PJM Manual 18:  
**PJM Capacity Market**

Revision: ~~15~~16

REVISED FOR PRICE  
RESPONSIVE DEMAND ~~June-28,~~  
2012

**Current Revision****Revision 15-16 (06/28/2012):**

*Exhibit 14: Illustrative Example of a Variable Resource Requirement Curve*

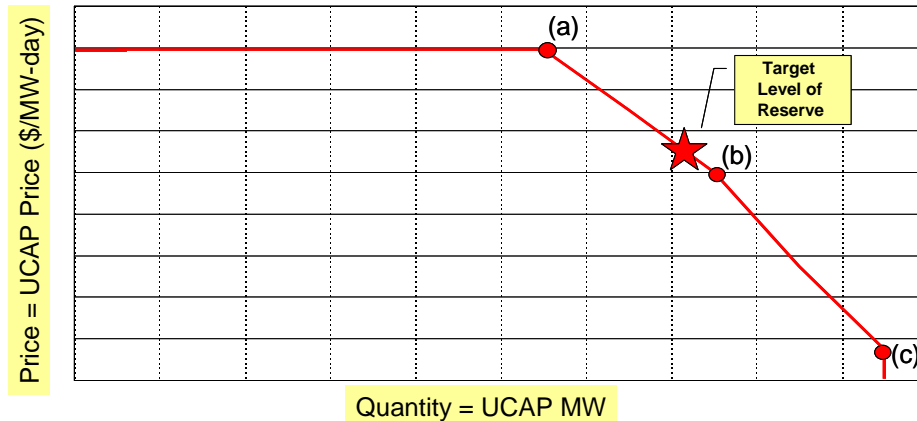
The Variable Resource Requirement Curve of Exhibit 1 will be further adjusted to reflect the impact of any PRD that is proposed in a PRD Plan and that is reviewed and accepted by PJM. To reflect accepted PRD Plans, the Variable Resource Requirement Curve will be shifted leftward along the horizontal axis by a quantity equal to the Nominal PRD Value multiplied by the FPR. This quantity represents the quantity of Unforced Capacity that would have been procured in the RTO on behalf of the PRD load but that is now not needed due to the PRD loads' commitment to reduce consumption. The curve will be shifted leftward in this manner only for those portions of the curve that are at or above the PRD Reservation Price, since the PRD load can be excluded only if the auction clears at or above that price. The Variable Resource Requirement Curve for each LDA in which the PRD resides (including the RTO curve) will be shifted in the exact same manner.
